**LOUDOUN COUNTY, VA
TECHNICAL REVIEW**

**PROPOSED
NEW
150-FOOT MONOPOLE
By
COMMUNITY WIRELESS STRUCTURES
(CWS)**

CWS SITE # 102 - Taylorstown

CMPT 2007-0005

ComStudy 2 Path Profile

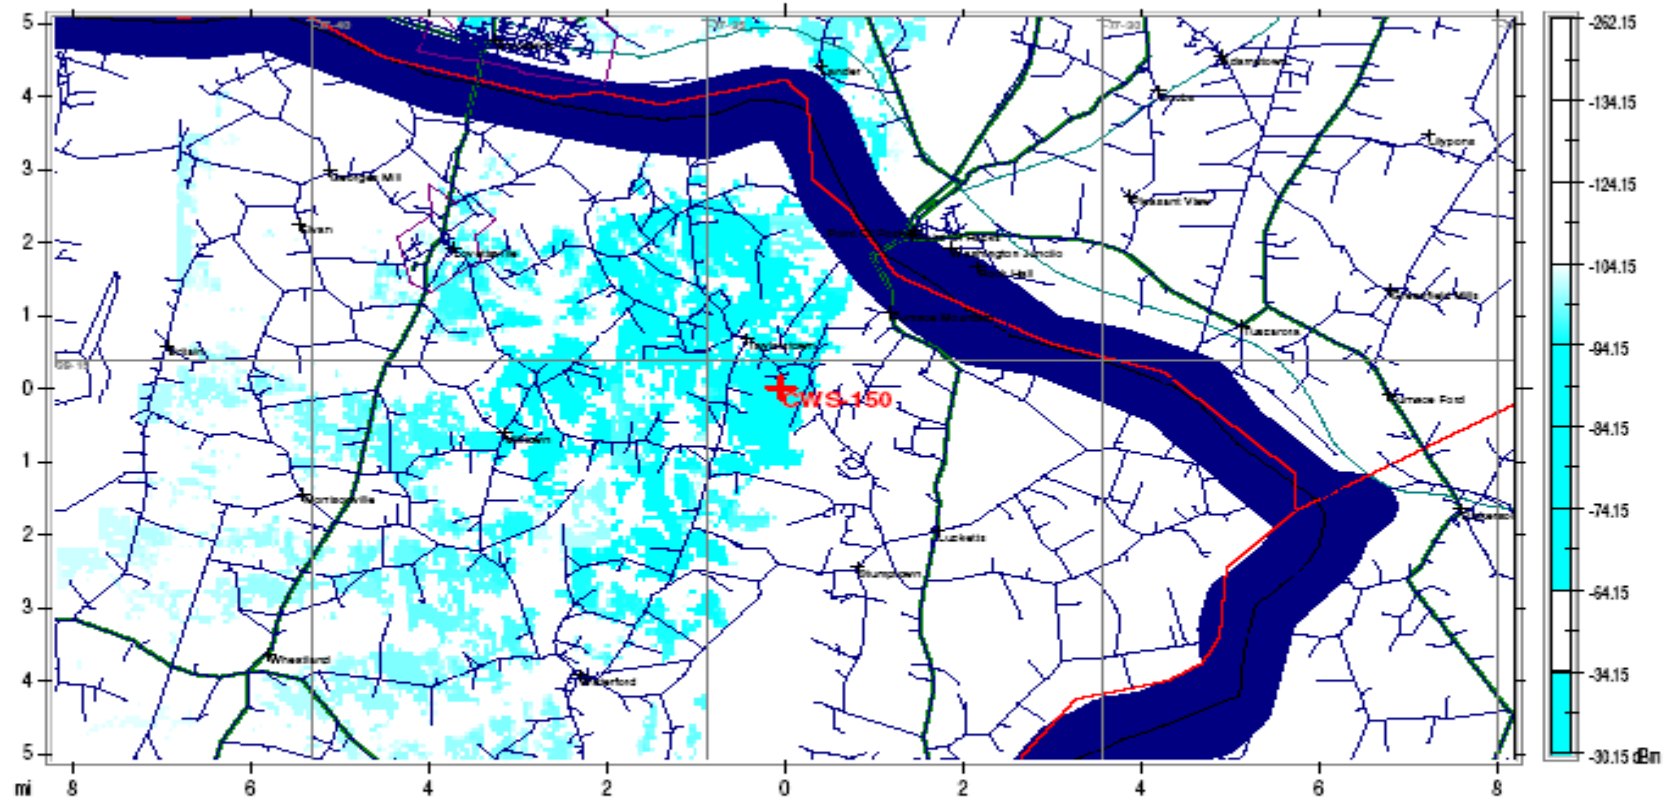
The nearest occupied dwelling to the monopole is approximately 600±', which is a 400% setback.

This tower should be adjusted to a 750' setback from a residence.

- Slight adjustment to achieve 750' setback from house.
- Structural drawings of the tower;
- Grounding specifications
- Certified RF Analysis report;

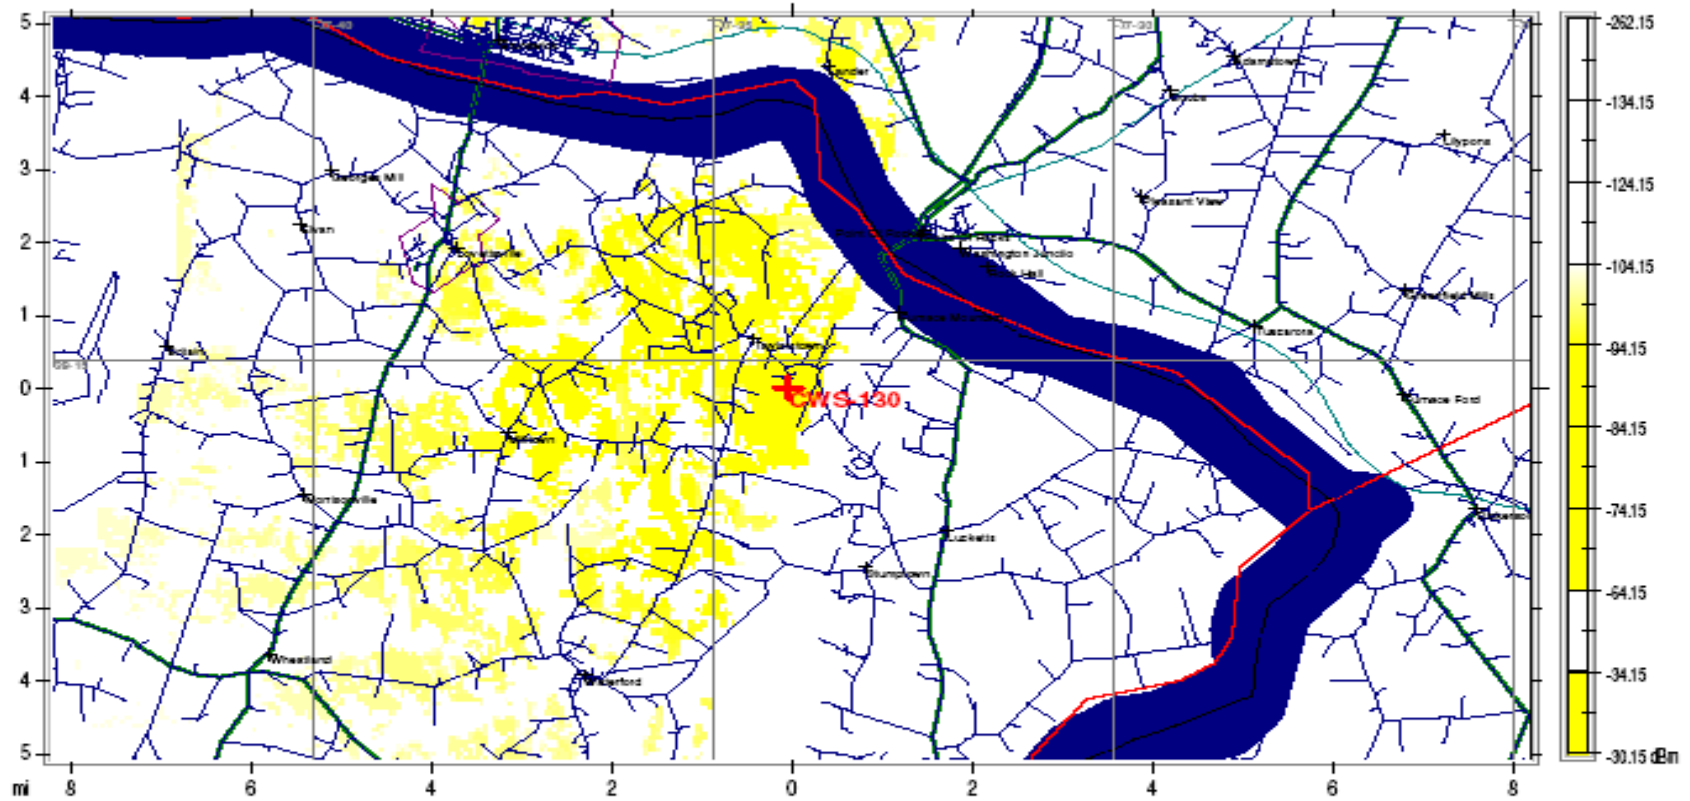
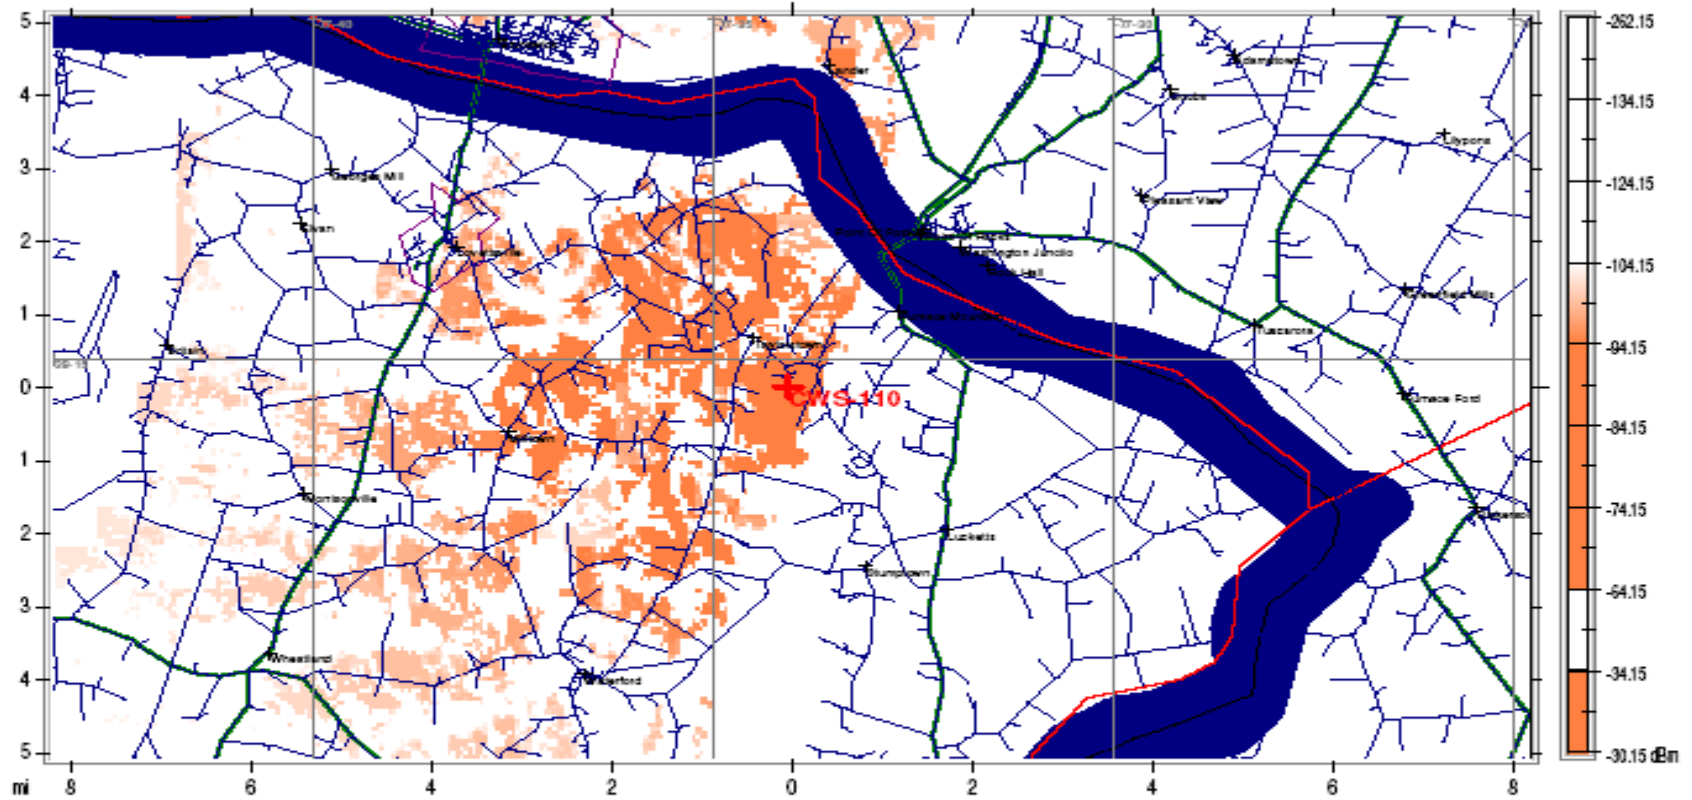
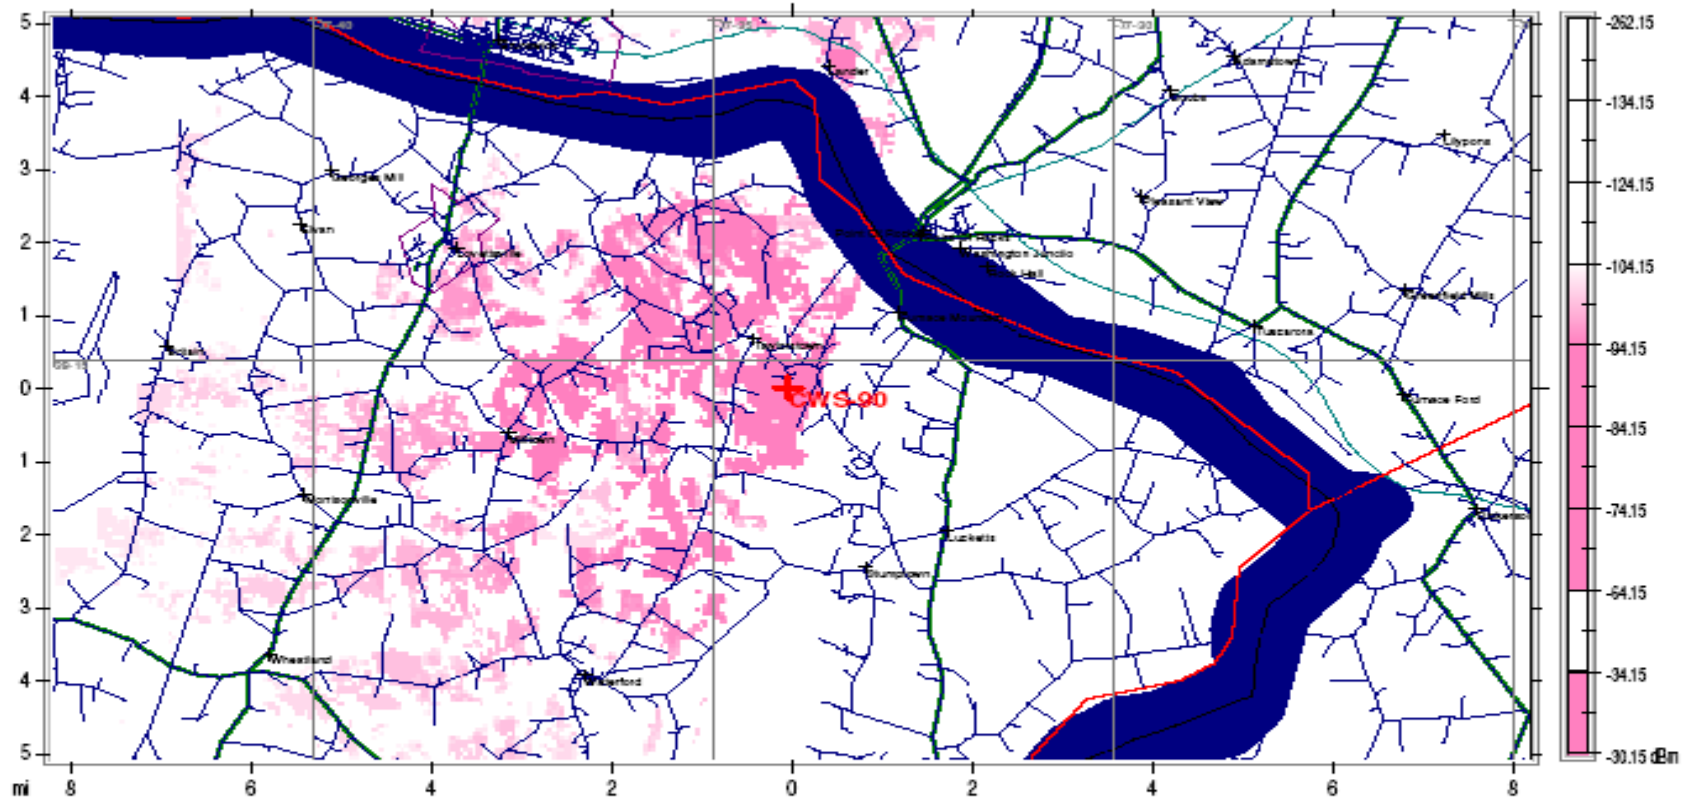
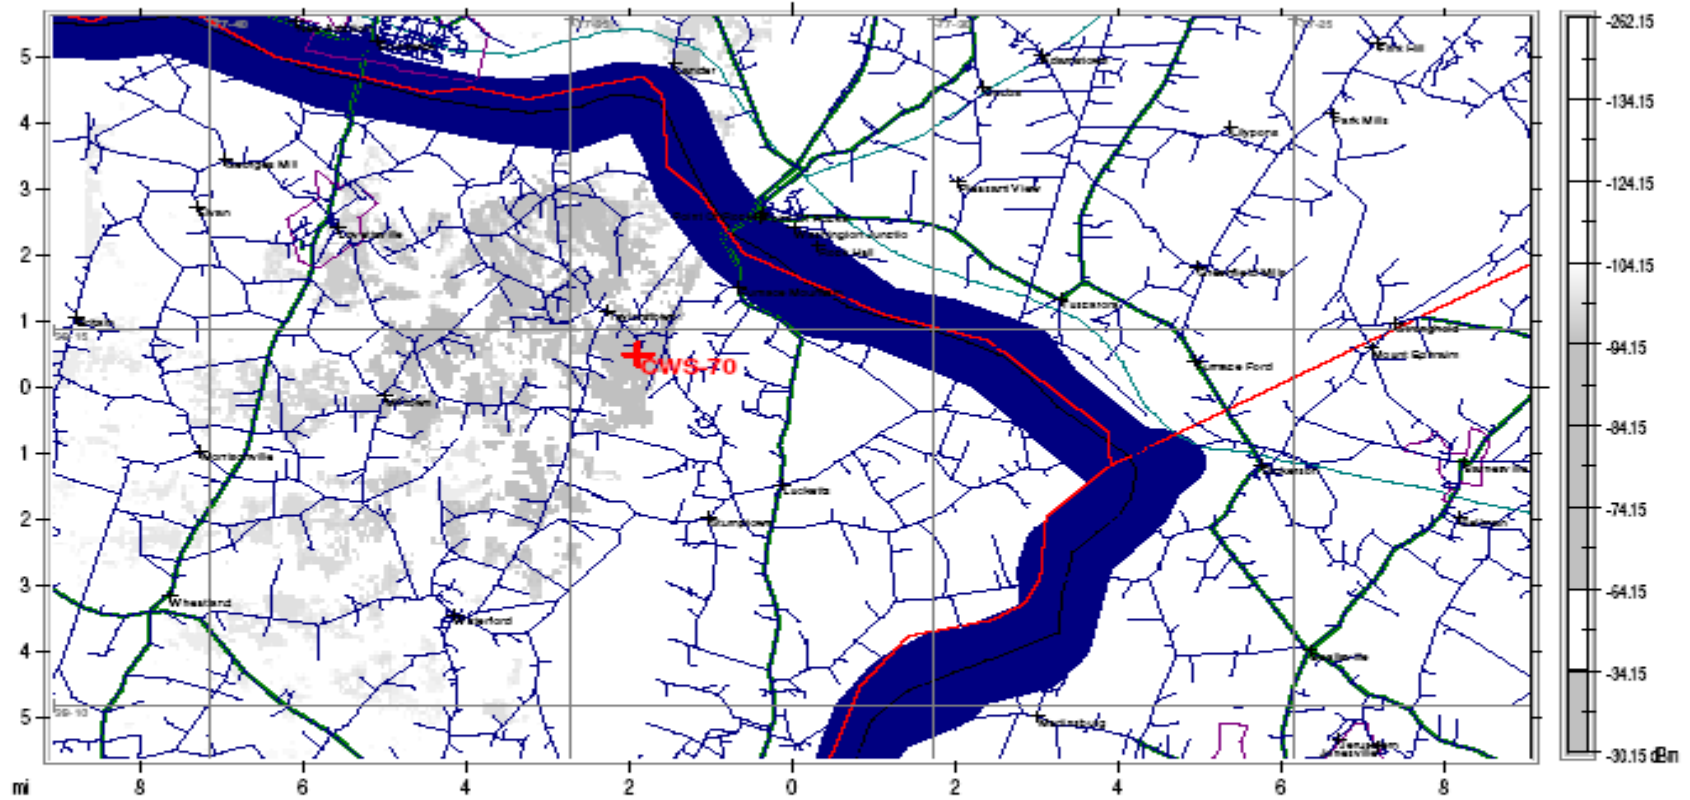
An independent RF analysis has been performed by this consultant with coverage maps appended to this report at the following heights:

150-foot	Propagation map – Blue
130-foot	Propagation map – Yellow
110-foot	Propagation map – Orange
90-foot	Propagation map – Pink
70-foot	Propagation map – Grey

150-foot	to	130-foot	0% difference in coverage
150-foot	to	110-foot	5% difference in coverage
150-foot	to	90-foot	10% difference in coverage
150-foot	to	70-foot	15% difference in coverage

It is this Consultant's opinion that the applicant will be able to meet their stated coverage objectives at a height of 110-foot.
